TRANSMITTAL OF INFORMATION ON CHANGES TO THE IT CORPORATION DESIGN AS REFLECTED IN THE DRAFT REMEDIAL DESIGN DOCUMENTS PACKAGE FOR OPERABLE UNIT 1

Reference: Draft Remedial Design Documents Package for Operable Unit 1, as Developed by IT Corporation, dated March 1998.

# CHANGES TO THE OU1 DRAFT REMEDIAL DESIGN DOCUMENT

WASTE PITS REMEDIAL ACTION PROJECT (WPRAP)
FERNALD, OHIO
FDF SUBCONTRACT NO. 985C000001

DRAWING NUMBER D-20-10-001

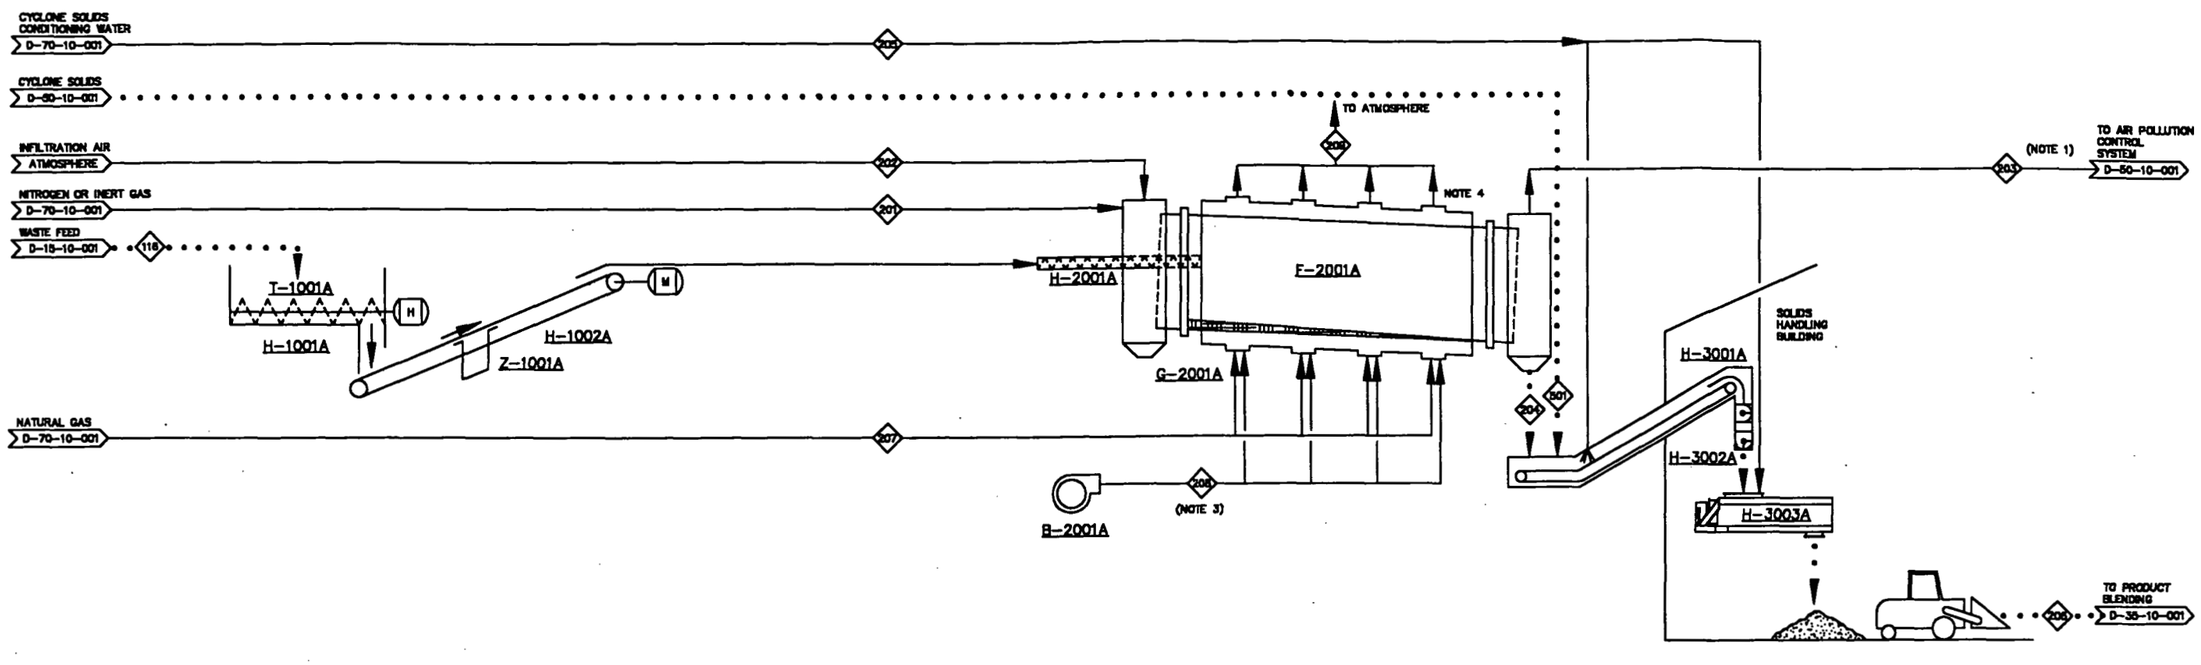
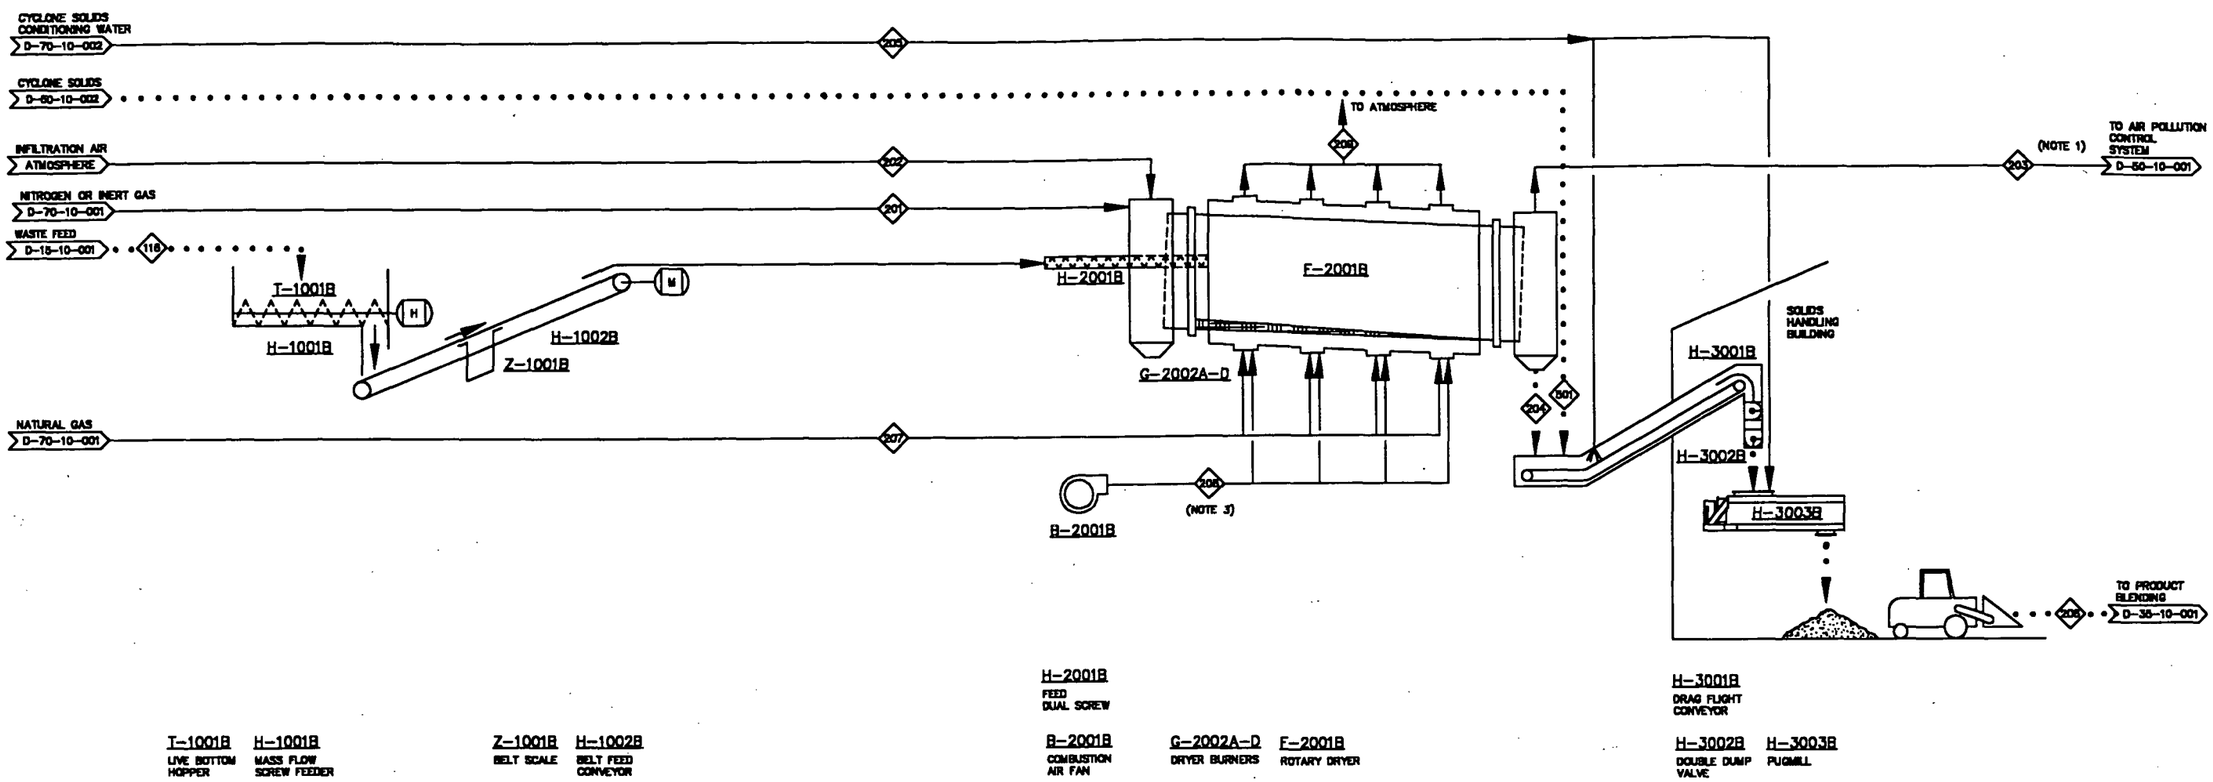
3) **Addition of inert gas purge to dryer**

The design verification test has indicated that significant non-condensible organic vapors will be present in the dryer off-gas stream. These organic vapors pose a potential explosion hazard if lower explosive limit concentrations are approached inside the WESP. An inert gas purge system (see PFD D-20-10-002, Rev. D, Stream 201) has been added to control the oxygen concentration in the dryer off-gas to less than eight percent.

5) **Dual Dryer Configuration versus Single Dryer:**

In Rev. B of the RD Documents Package, a single, large dryer nine feet by 60 feet long (heated length) was included (see PFD D-20-10-001, Rev. B). Based upon vendor responses, the new design includes a dual-dryer (7.5 feet in diameter by 46 feet heated length) configuration which will improve process reliability with out impacting the single train Gas cleaning system. These dryers are depicted on the following two PFDs: D-20-10-001 & -002, Rev. D.

Separate dryer feed and product handling systems are used for each dryer. A 46 foot heated shell length will have considerably less thermal stress than a 60 feet long heated shell. These benefits are realized with out impacting the overall soil processing capacity, or moisture evaporative capacity.

6) **Elimination of Sweep gas/Recuperative heater:**

In Rev. B of the RD Documents Package, a 3000 ACFM sweep air rate to drive the water vapor and volatiles from the dryer into the gas cleaning system was assumed (see PFD D-20-10-001, Rev. B, Stream 205). Based on operating experience with a similar process, sweep gas is not required for this purpose. The forced continuous sweep air has therefore been deleted. Normal infiltration air rates combined with inert purge gas will be used as the design basis. An infiltration air leakage rate is assumed based on actual operational conditions from a similar process.

The system initially included a recuperative heater (see PFD D-20-10-001, Rev. B, item E-2001) to improve overall energy efficiency of the drying system. Utilizing the dual dryer configuration, the maximum thermal input required to both dryers and the thermal oxidizer is within the proposed natural gas usage levels without the use of a recuperative heater. Elimination of the recuperative heater also simplifies the system design.

7) **Elimination of dual fuel firing:**

In Rev. B of the RD Documents Package, provisions were made for fuel oil firing on the dryer burners (see PFD D-20-10-001, Rev. B, Streams 202 and 203). Several factors involved with fuel firing such as corrosion and fouling of external drum surfaces, soot deposition, NOx and SOx emissions, and piping complexities of multiple burner configurations have led to the deletion of the fuel oil firing provision.

DRAWING NUMBER D-50-10-001

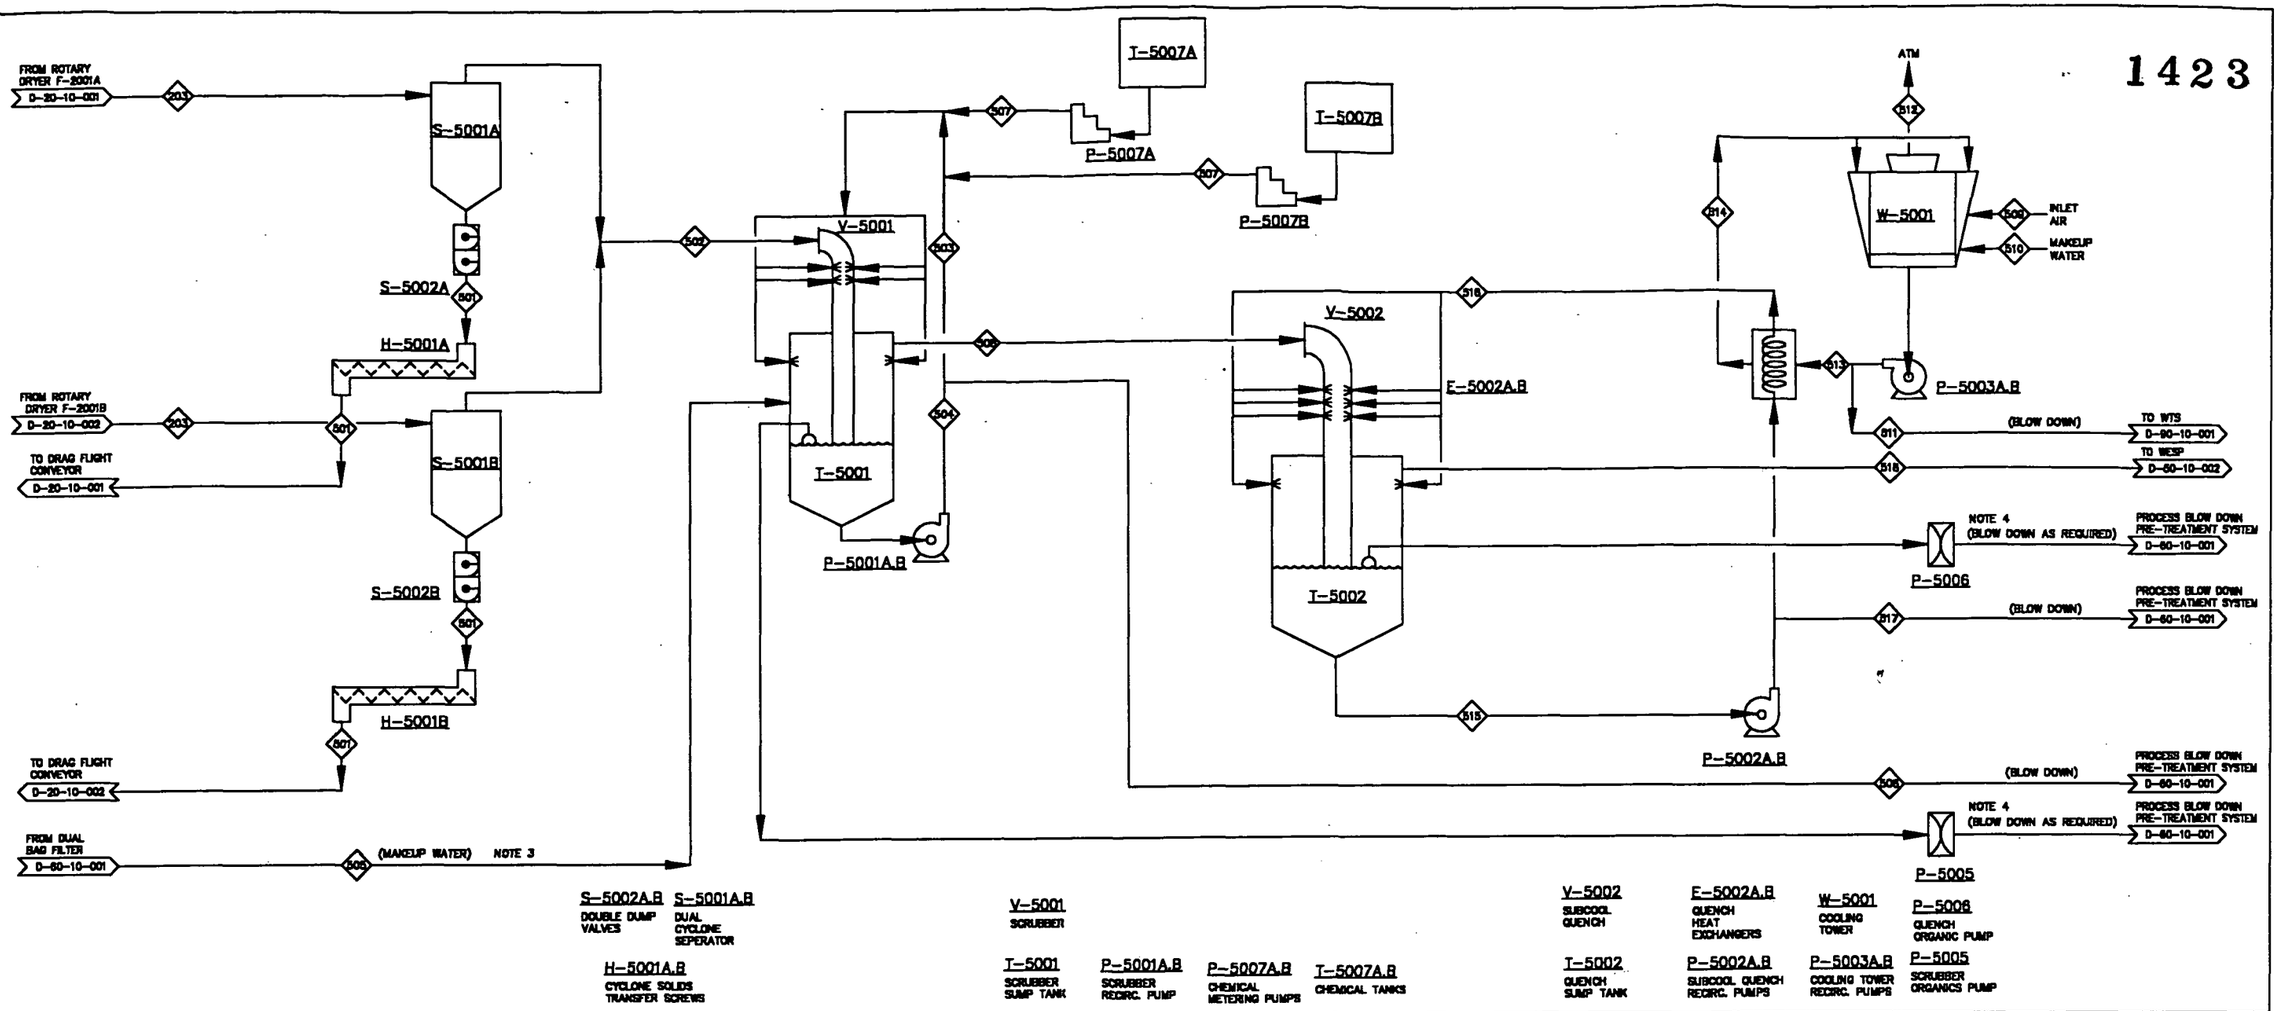
1) **Deletion of optional chiller**

In Rev. B of the RD Documents Package, an "optional" chiller (item Z-5001) was included to cool dryer off-gases to approximately 40 Degrees Fahrenheit condensing the heavy or condensible hydrocarbons (see PFD D-50-10-001, Rev. B, of Volume 1 of 3). Even though the chiller can condense the heavier hydrocarbon compounds, it is not effective in condensing the light hydrocarbons which testing shows will be present in the dryer off-gas stream. For this reason the optional chiller has been deleted. Dryer off-gases will be sub-cooled to a nominal 100 Degrees Fahrenheit using sub-cooling contact sprays (items E-5002A, B) to remove condensible hydrocarbons (see PFD D-50-10-001, Rev. D, attached).

8) **Deletion of the Venturi Scrubber**

In Rev. B of the RD Documents Package, a venturi scrubber (see PFD D-50-10-001, Rev. B, item S-5002) was included upstream of a contact scrubber. The purpose of the venturi scrubber was to enhance particulate removal prior to the contact scrubber to reduce the potential for fouling of the contact scrubber internal packing.

The revised gas cleaning system design is based on operating experience with a similar process and provides for particulate removal in a two-stage scrubber/subcool quench without effecting the operation of the WESP and HEPA filters.

9) **HEPA filter moved to the suction side of the induced draft (ID) fan:**

In Rev. B of the RD Documents Package, the HEPA filters were shown to be downstream of the ID fan (see PFD D-50-10-001, Rev. B). This location was initially chosen to minimize pressure on the filter housing. Elimination of the venturi scrubber has reduced the vacuum upstream of the ID fan sufficient to allow placement of the HEPA filters in this position. It is preferred to operate the HEPAs at a slight negative pressure to minimize the potential for fugitive emissions from filters. The design has been improved from an ALARA standpoint.

10) **Deletion of the mist eliminators:**

A dual mist eliminator was included in Rev. B of the RD Documents Package, to reduce the particulate/moisture droplet loading to the WESP (see PFD D-50-10-001,

Rev. B, item S-5003). The revised design incorporates a WESP unit that is sized to handle the particulate/droplet loadings without the need for a mist elimination step. The mist eliminators provided no additional process benefit and would be susceptible to plugging. The mist eliminators have been deleted.

DRAWING NUMBER D-50-10-002

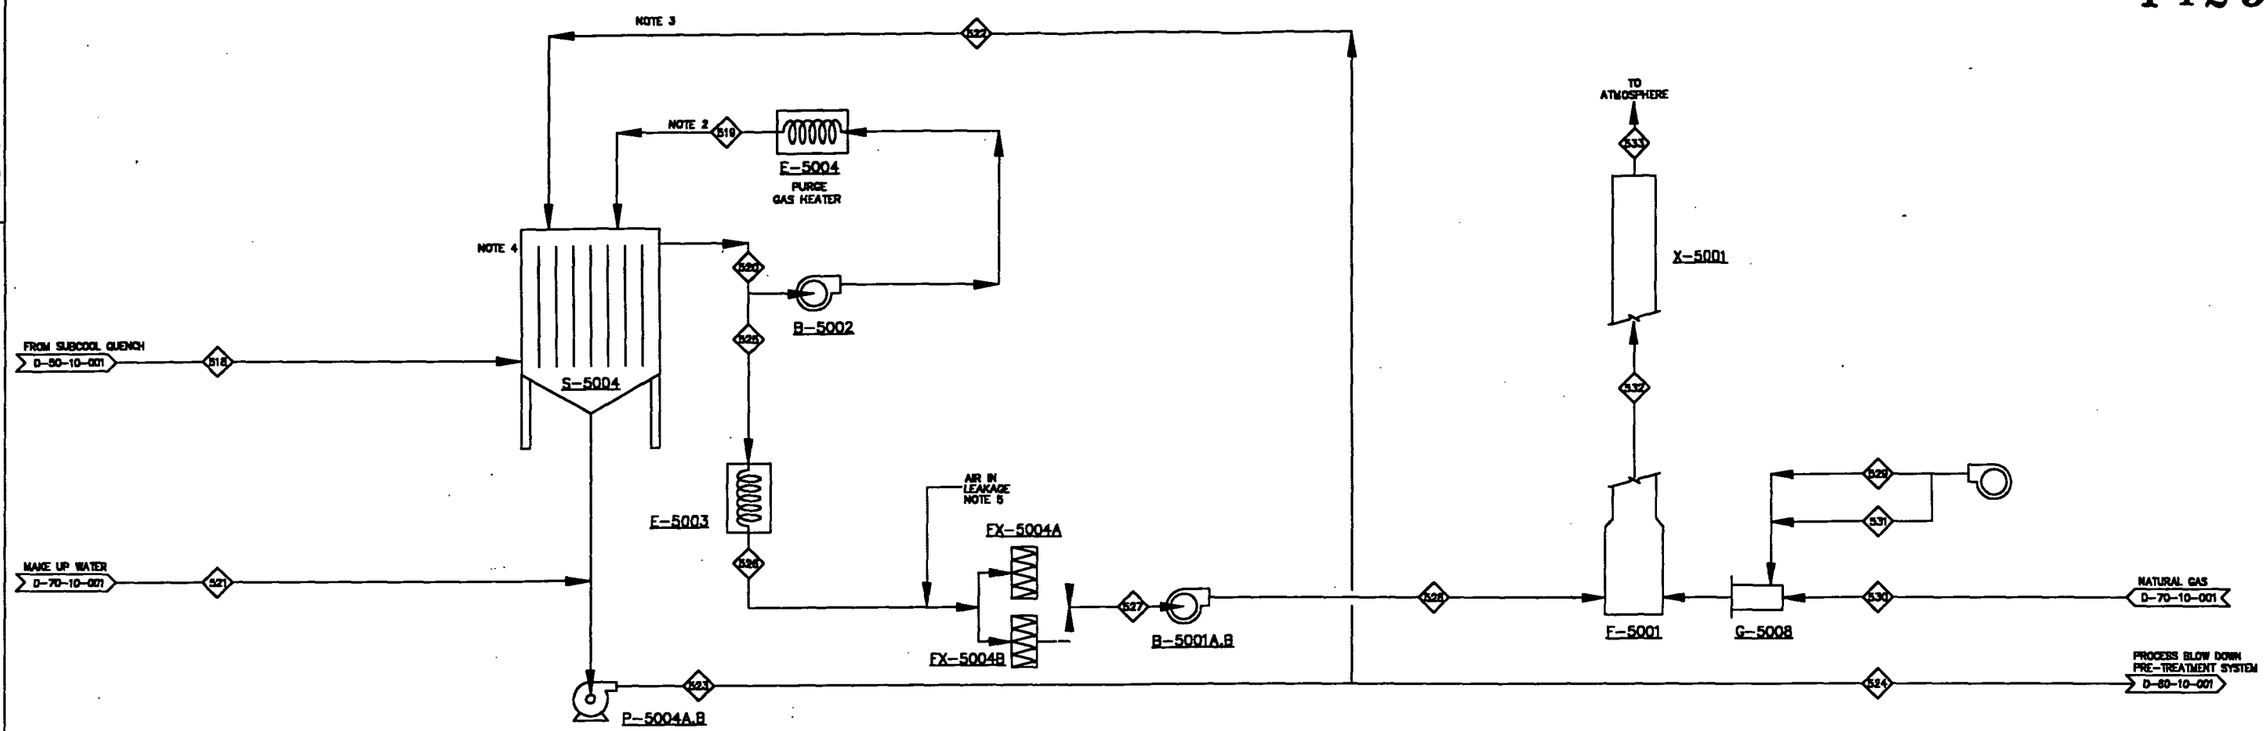
2) **Addition of optional thermal oxidizer and deletion of carbon bed absorber:**

In Rev. B of the RD Documents Package, a carbon absorber (S-5006) and an "optional" thermal oxidizer (F-5001) were included to remove non-condensible hydrocarbons from the dryer off-gas stream (see Section 2.6 of the Description of Operation and Processes and PFD D-50-10-001 of Volume 1 of 3). Carbon bed absorbers are effective in removing heavier hydrocarbons but are not effective in removing very light hydrocarbons and carbon monoxide (CO) which testing shows

will be present in the dryer off-gas stream. For this reason the carbon bed absorber has been deleted. The thermal oxidizer is no longer optional and is included in the system because of its effectiveness in removal of carbon monoxide (CO) and total hydrocarbons (THC).

The gases exiting the thermal oxidizer at 1600 degrees Fahrenheit are directed to the stack and then discharged to the atmosphere hot. The hot gases inherently provide for greater enhanced dispersion and minimized ground level concentrations of any flue gas constituent as compared to the relatively cool 120 degree Fahrenheit exhaust initially projected.
